# CITY OF ALBUQUERQUE

RE: **Durango Subdivision, Units 3 - 5**  
**Tr H, Durango Unit 1 & Tr A Durango Unit 3A**  
**Drainage Report Stamp Date: 3/5/15**  
**Unit 3 Grading Plan Stamp Date: 8/12/15 (previously approved for Plat, 8/18/15)**  
**Unit 3A Grading Plan Stamp Date: 2/15/19**  
**Unit 4 Grading Plan Stamp Date: 8/12/15 (previously approved for Grading & Plat, 8/18/15)**  
**Unit 5 Grading Plan Stamp Date: 2/15/19**  
**Hydrology File: C09D012**

Based on the submittal received on 2/15/19 the above-referenced Grading Plans cannot be approved for Preliminary Plat, Grading Permit, and Work Order until the following are corrected:

Re: Durango Subdivision, Units 3 - 5  
Tr H, Durango Unit 1 & Tr A Durango Unit 3A  
Drainage Report Stamp Date: 3/5/15  
Unit 3 Grading Plan Stamp Date: 8/12/15 (Approved for Plat, 8/18/15)  
Unit 3A Grading Plan Stamp Date: 1/18/19  
Unit 4 Grading Plan Stamp Date: 8/12/15 (Approved for Grading, 8/18/15)  
Unit 5 Grading Plan Stamp Date: 1/18/19  
Hydrology File: C09D012

**DURANGO**  
UNIT 5  
**GRADING AND DRAINAGE PLAN**

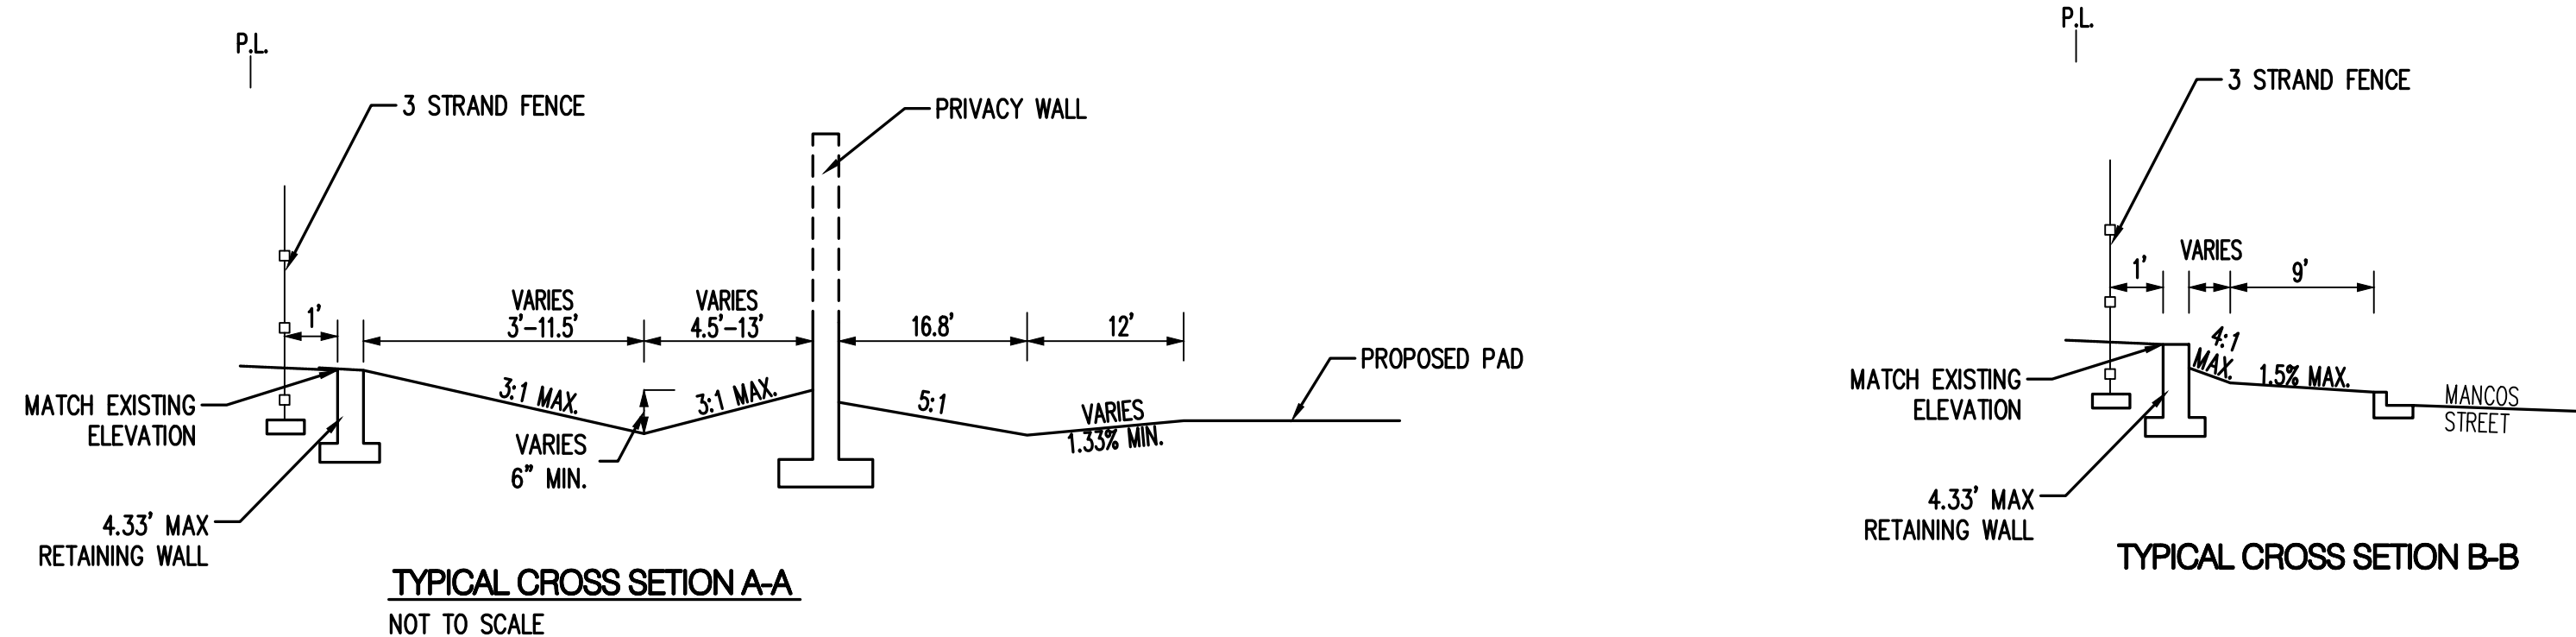
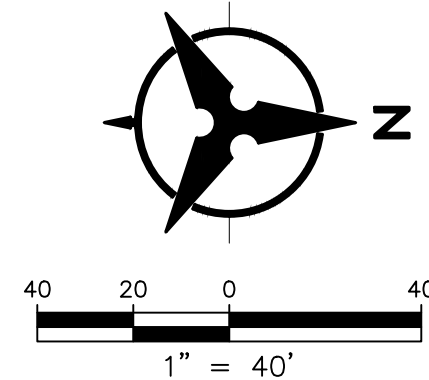
5. Prior to Unit 5 ROFG, The backyard ponds for Lots 4-16, Unit 5 need a [Drainage Covenant \(No Public Easement\)](#) to ensure these ponds don't become a hazard for the homeowners in Unit 3. A recorded document will be needed at ROFG, provide a draft when resubmitting.
6. This project requires an ESC Plan, submitted to the Storm Water Quality Engineer (Curtis Cherne PE, [ccherne@cabq.gov](mailto:ccherne@cabq.gov) or 924-3420).
7. For Information: Prior to Unit 3/3A ROFG, a temporary drainage easement on the temporary ponds will be needed, unless the upstream road portions have been built.

11. The backyard ponds for Lots 4-16, Unit 5 need a protective covenant; either a restrictive covenant for the homeowner's (enforced by HOA) or a Drainage Covenant (No Public Easement) to ensure these ponds don't become a hazard for the homeowners in Unit 3. However this is resolved, a recorded document will be needed at Final Plat (provide a draft when resubmitting). **A drainage covenant will be utilized and will be required before Release of Financial Guaranty.**

WALL DRAINAGE STRUCTURE DETAIL

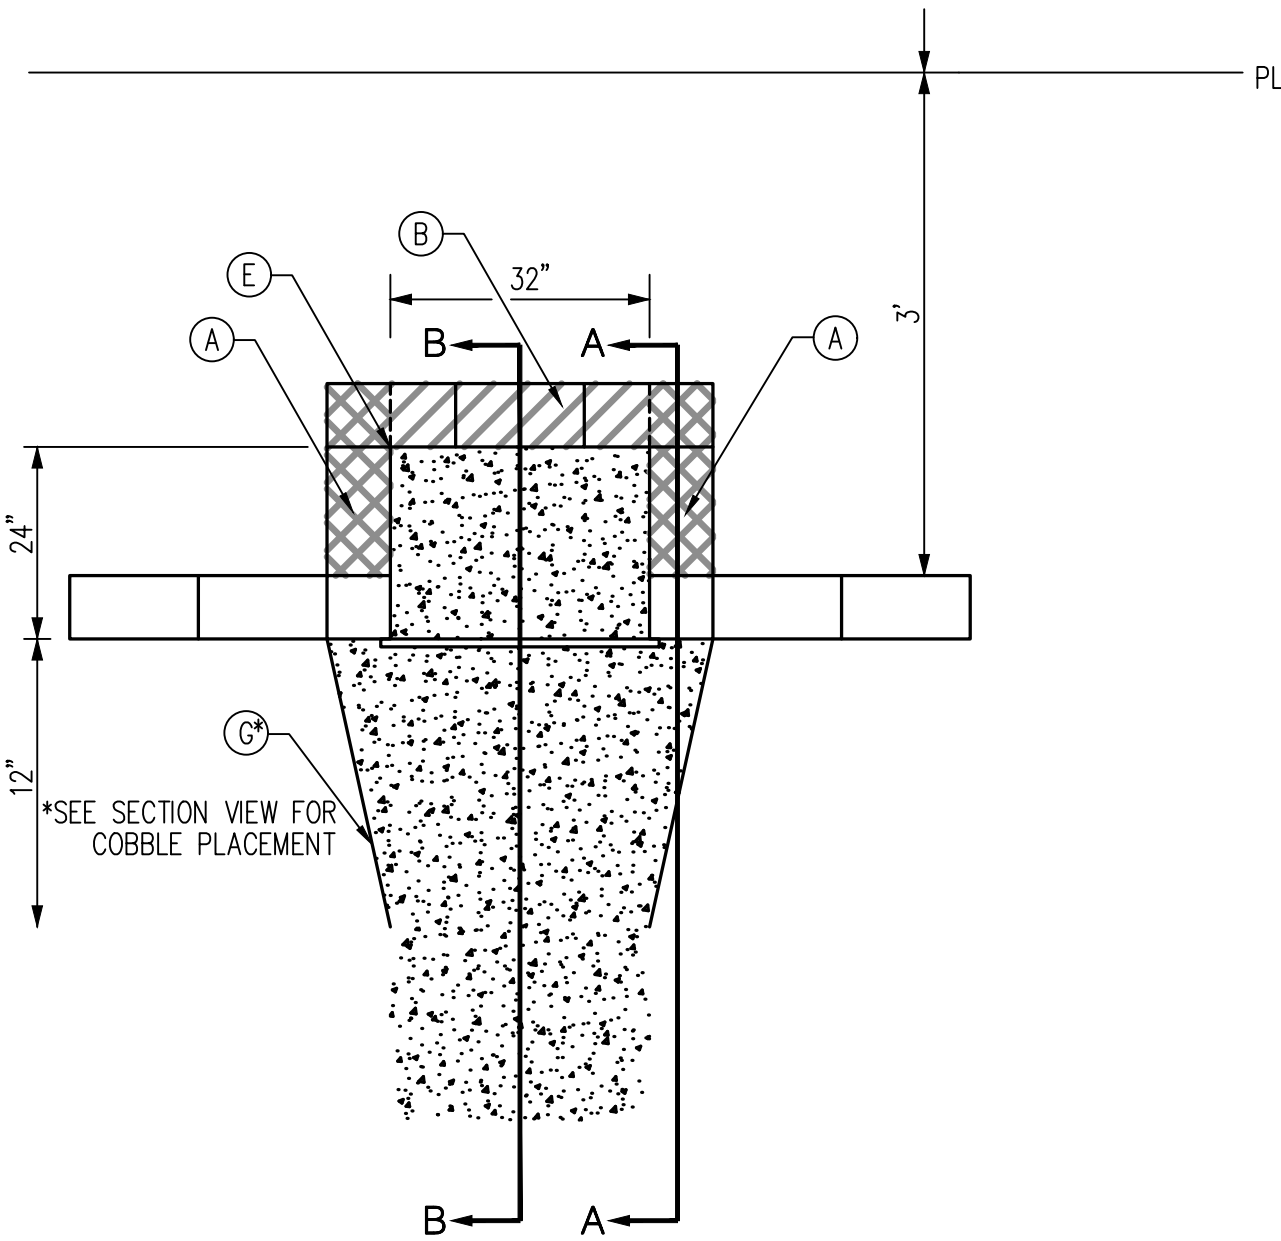
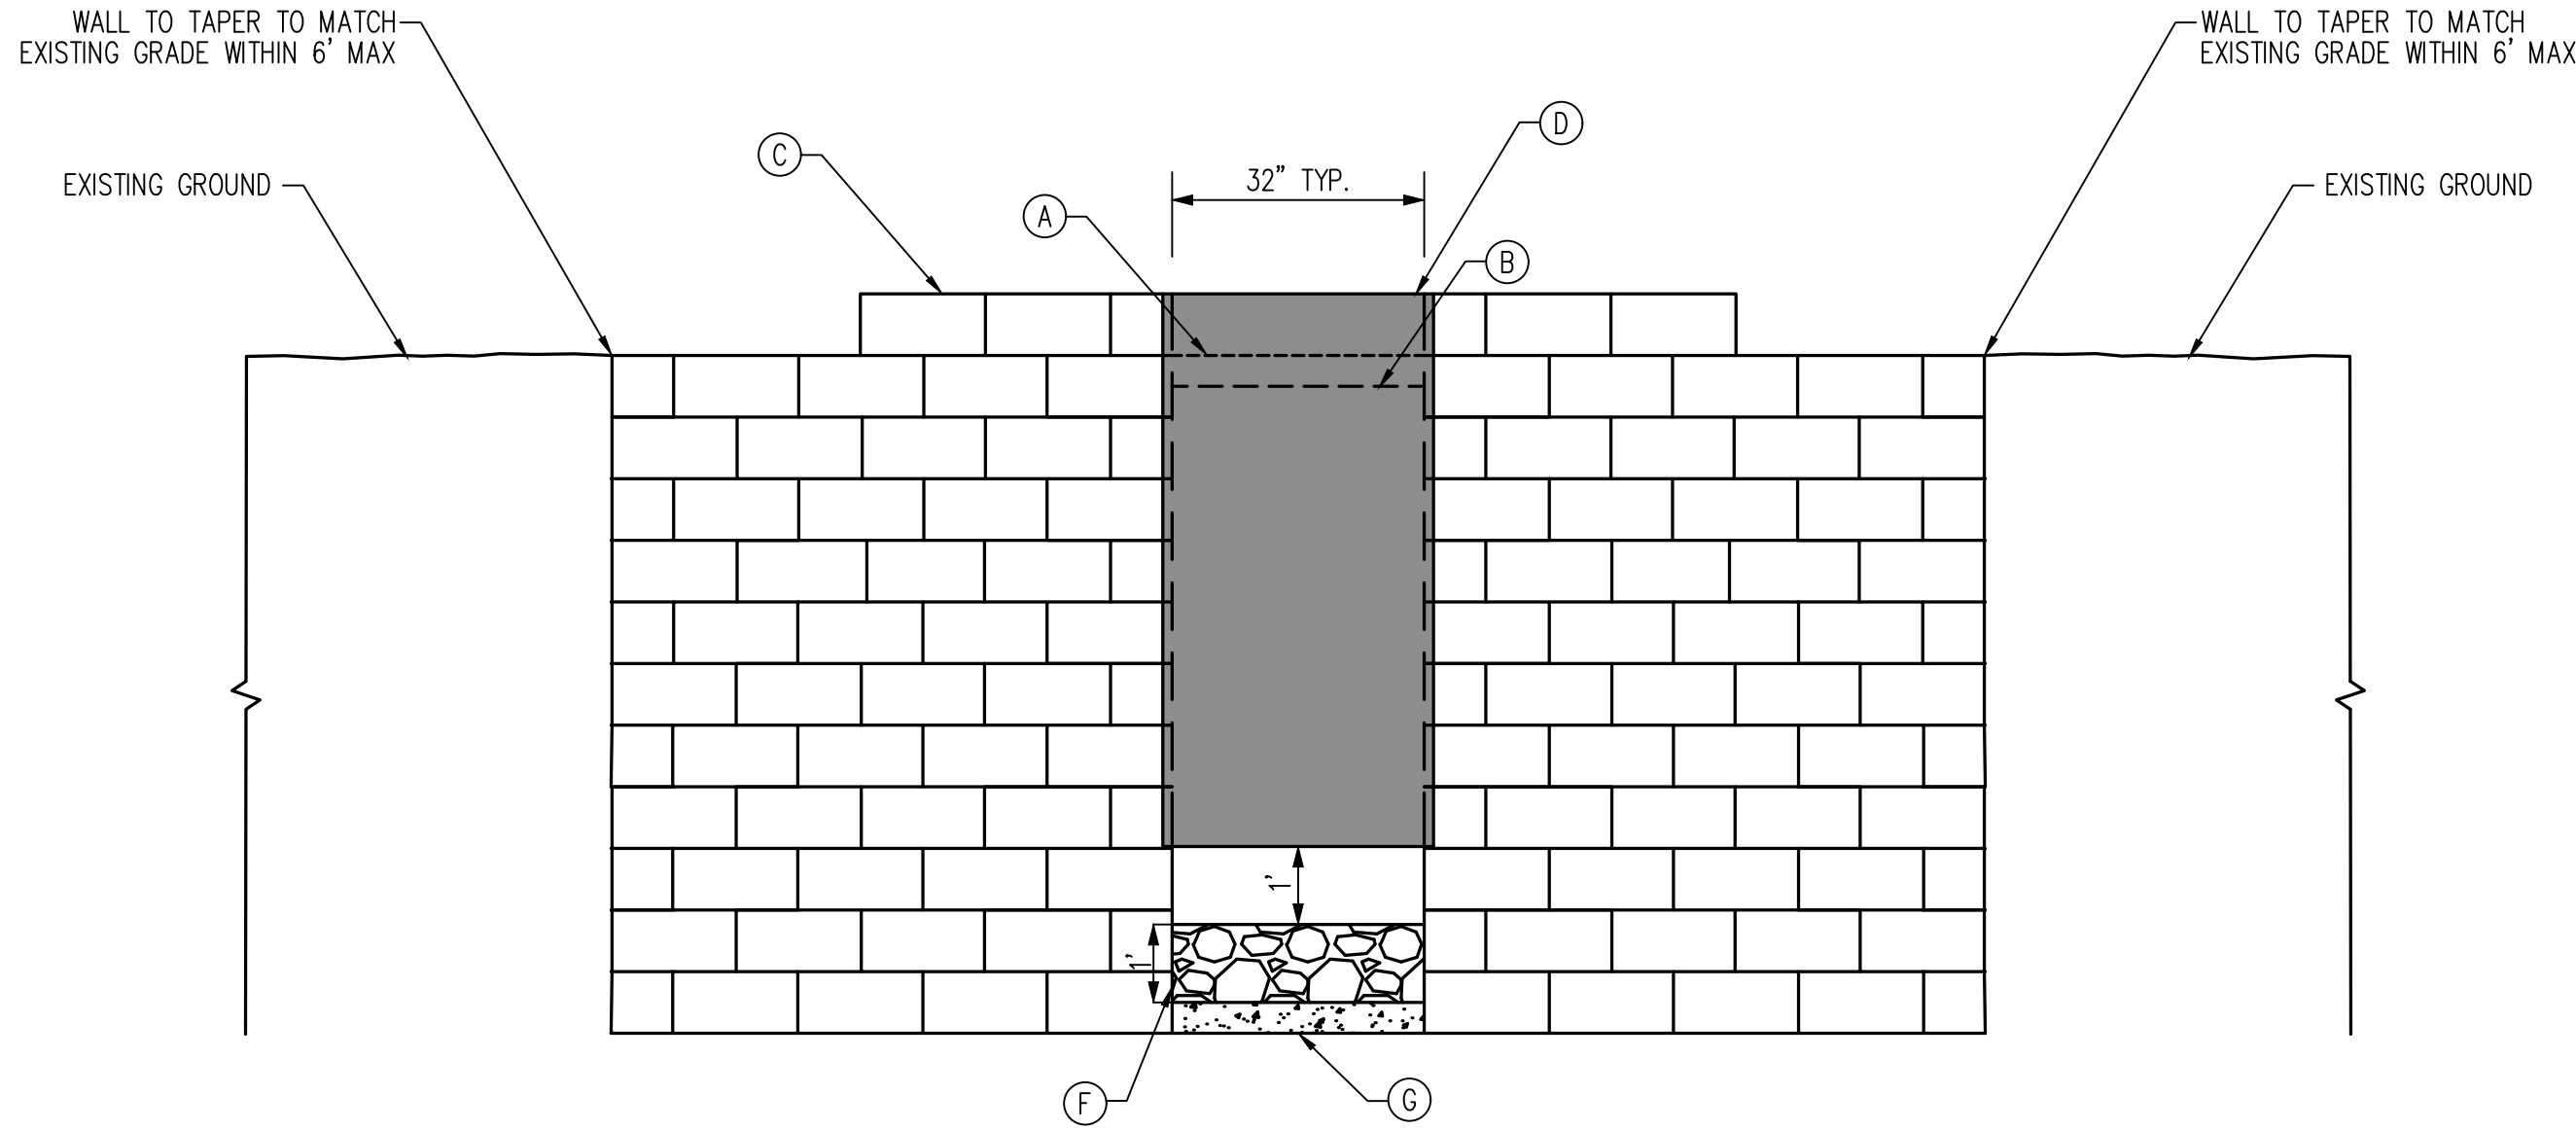
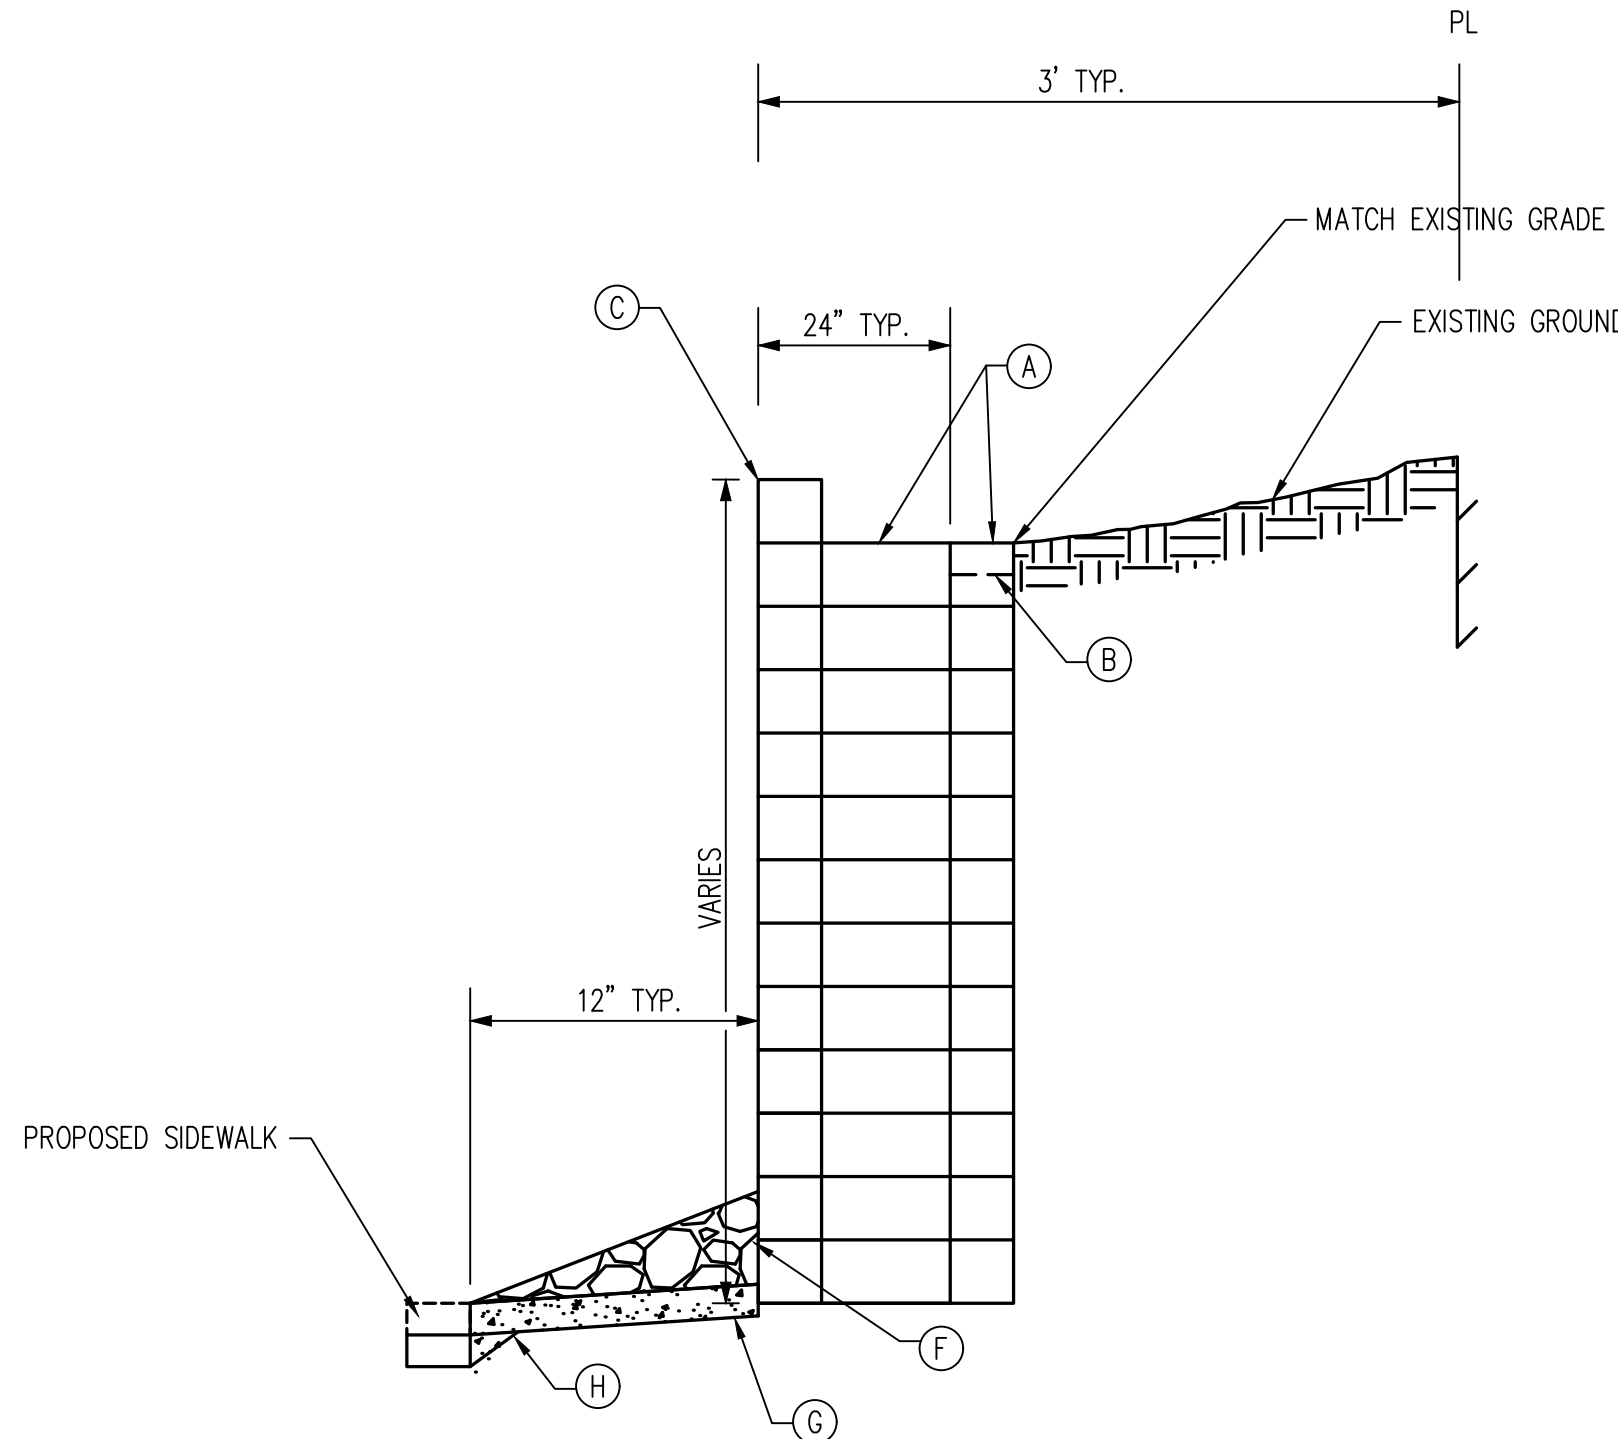
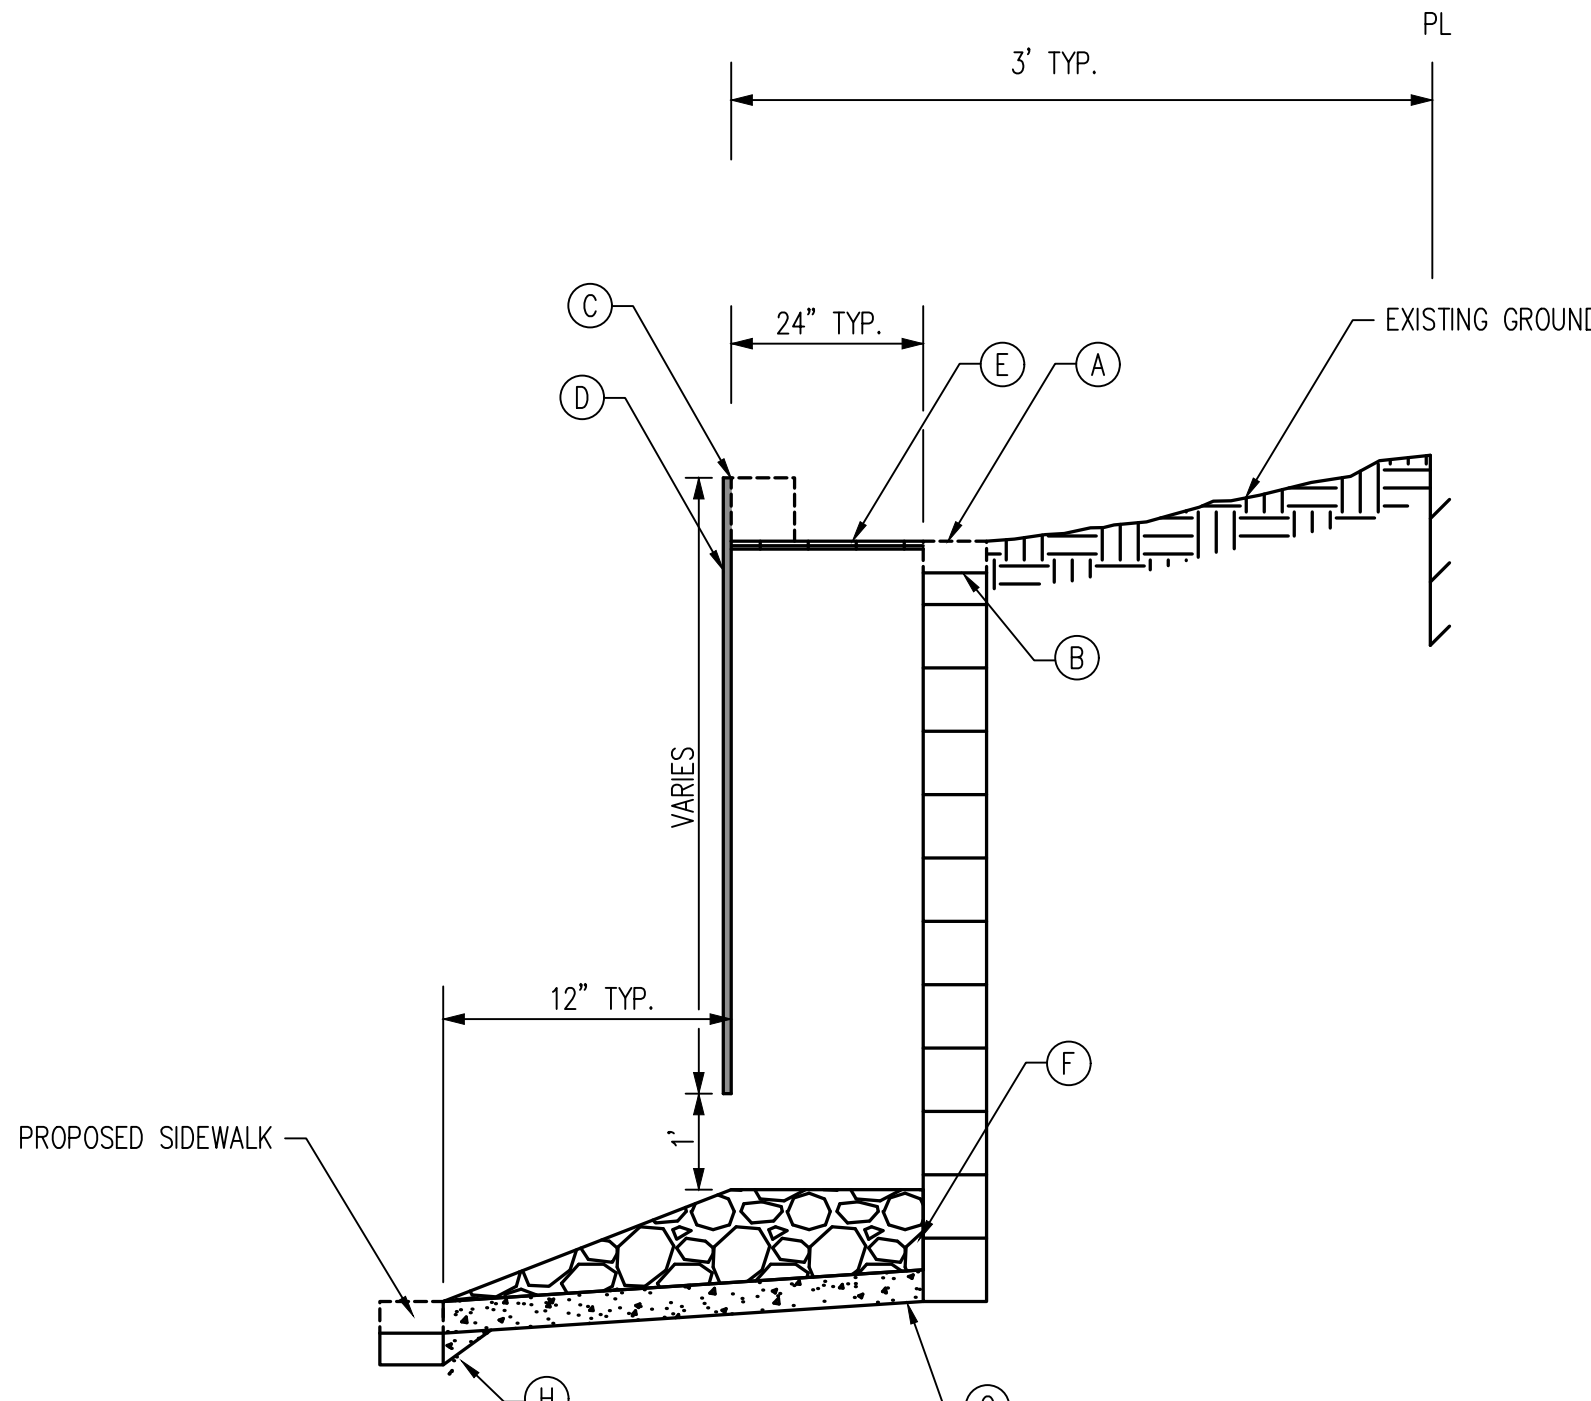
8. Special care must be taken while grading adjacent to the Open Space. Identify all concentrated flow paths entering this subdivision and provide grade control and controlled flowpaths into the subdivision. Provide details showing how this will be accomplished, similar to what was required for Del Webb 3&4. Ensure all slopes are stabilized to prevent headcutting and erosion back into the Open Space. **A grade control wall has been added to the grading plan and the detail for location at concentrated flow locations.**
